RE: Staff Report RPF014 -16 to General Committee, November 28, 2016.

<u>DOWNTOWN THREE (3) HOUR PARKING LIMIT – BERCZY STREET</u>

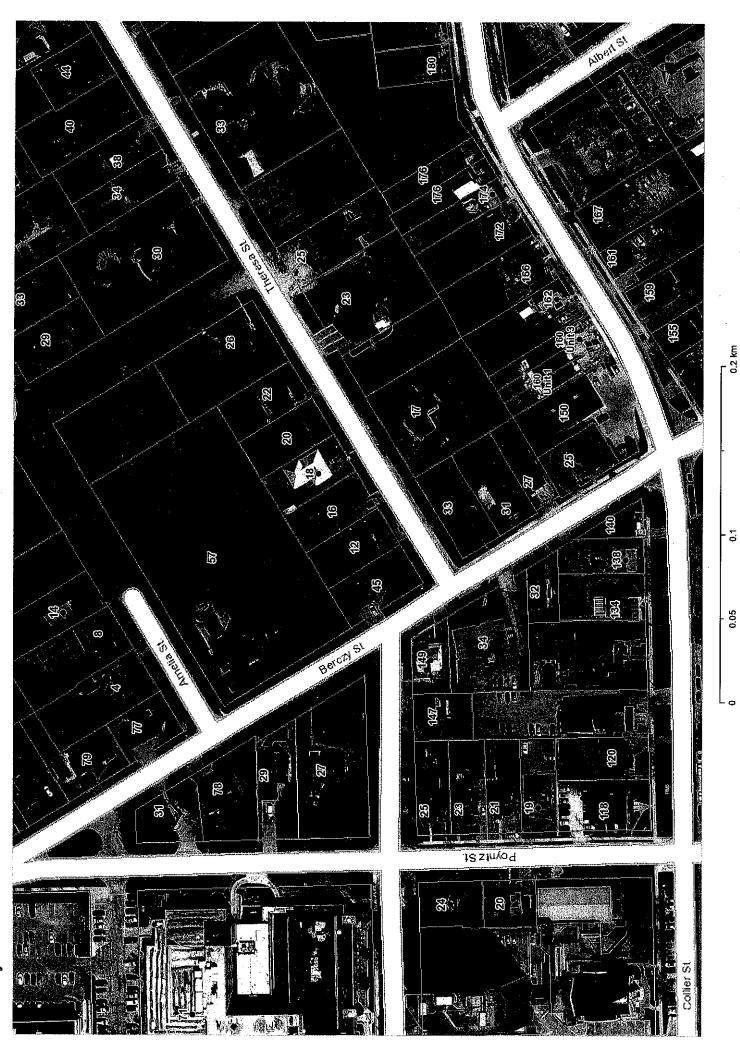
The report indicates that a questionnaire was mailed to 26 property owners on Berczy Street between Collier Street and Amelia Street. However, there are only 19 properties at most on this section of Berczy Street.

There are 6 single family residential homes and one small apartment building with 11 units on Berczy Street between Collier and Amelia. There are two additional properties on abutting streets that have driveway access to Berczy Street. (Aerial photo attached)

Parking should not be permitted on the east side of the Berczy between Collier Street and
1.5 meters beyond the second driveway even if parking is permitted on the east side of Berczy.

The space between the driveways at #25 and #27 Berczy is only 6.5 metres. When the required 1.5 metres clearance to each of the driveway is maintained the effective space is 3.5 metres, which is insufficient for a parking spot. Significant by-law enforcement resources would be required to enforce this if parking is not prohibited at this spot.

The distance from the Collier Street intersection to the first driveway is approximately 26 metres. The by-law prohibits parking a minimum of 9.0 metres from all intersections and 1.5 metres from driveways. Accordingly, the effective parking area is 15.5 metres. Prohibitions parking in this area would only reduce possible parking spots by 2.
